Industry/TSTF Standard Technical Specification Change Traveler

Revise LCO 3.5.5 for RCP seal injection flow resistance

NUREGs Affected: 1430 1431 1432 1433 1434

Figure 3.5.5-1 (page 1 of 1)
Seal Injection Flow Limits

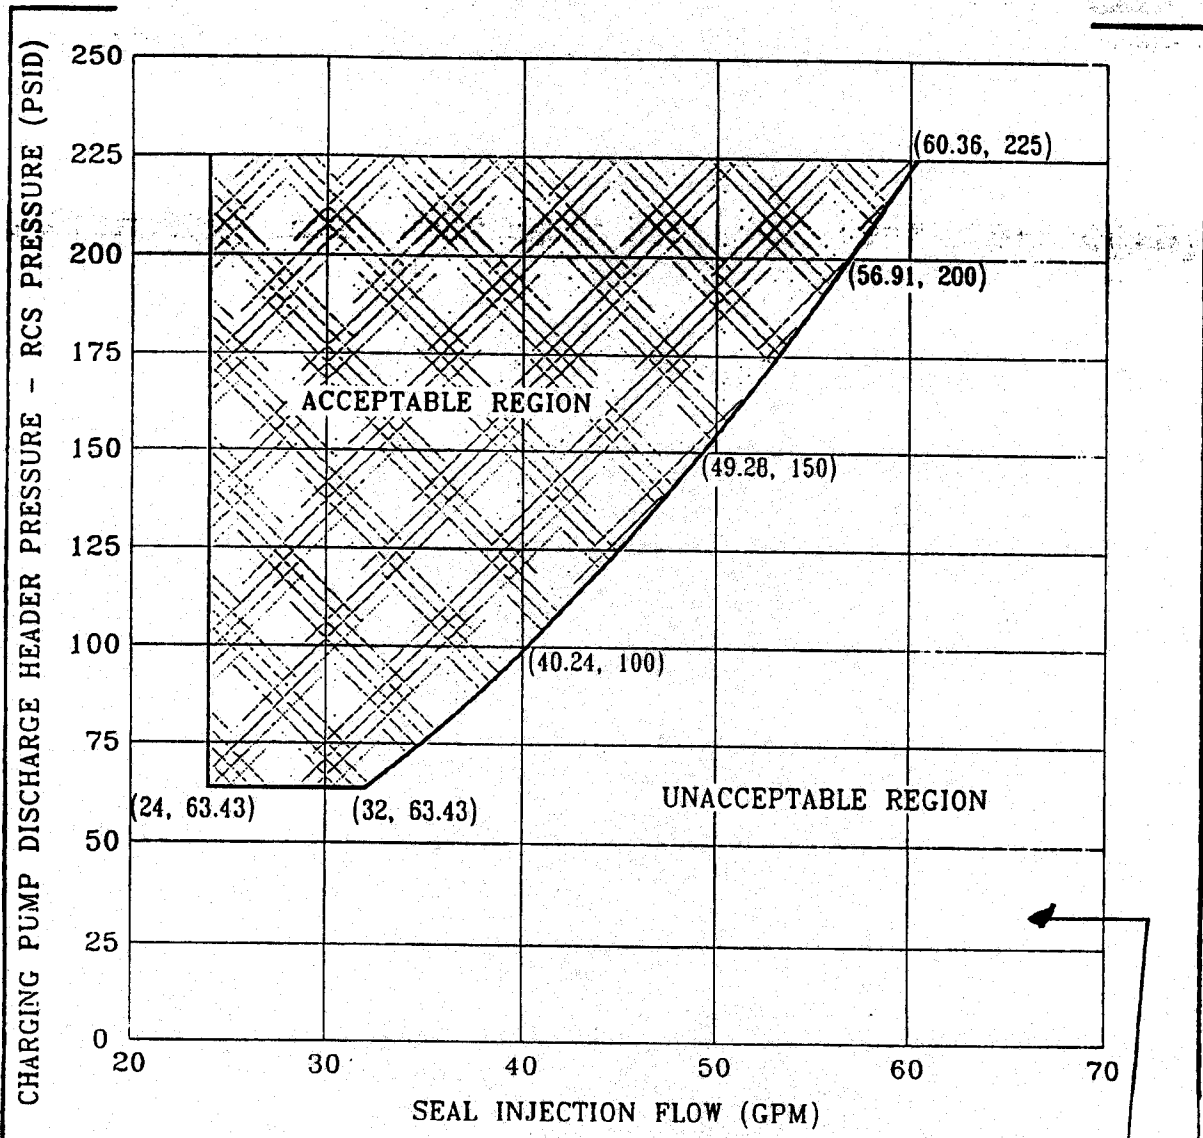
"Reactor coolant pump seal injection flow [resistance] shall be \leq [40] gpm with [centrifugal charging pump discharge header] pressure \geq [2480] psig and the [charging flow] control valve full open or \geq [0.2117] ft/gm² or within the limit of Figure 3.5.5-1."

"Verify manual seal injection throttle valves are adjusted to give a flow [resistance] [of \leq [40] gpm] with [centrifugal charging pump discharge header] pressure \geq [2480] psig and the [charging flow] control valve full open or \geq [0.2117] ft/gm² or within the limit of Figure 3.5.5-1."

Change Description: Added Figure 3.5.5-1

The LCO is not strictly a flow limit, but rather a flow limit based on a flow line resistance. In order to establish the proper flow line resistance, a pressure and flow must be known. The flow line resistance is established by adjusting the RCP seal injection flow in the acceptable region of Figure 3.5.5-1 at a given pressure differential between the charging header and the RCS. The centrifugal charging pump discharge header pressure remains essentially constant through all the applicable MODES of this LCO. A reduction in RCS pressure would result in more flow being diverted to the RCP seal injection line than at normal operating pressure. The valve settings established at the prescribed centrifugal charging pump discharge header pressure result in a conservative valve position should RCS pressure decrease. The flow limits established by Figure 3.5.5-1 ensures that the minimum ECCS flow assumed in the safety analyses is maintained.
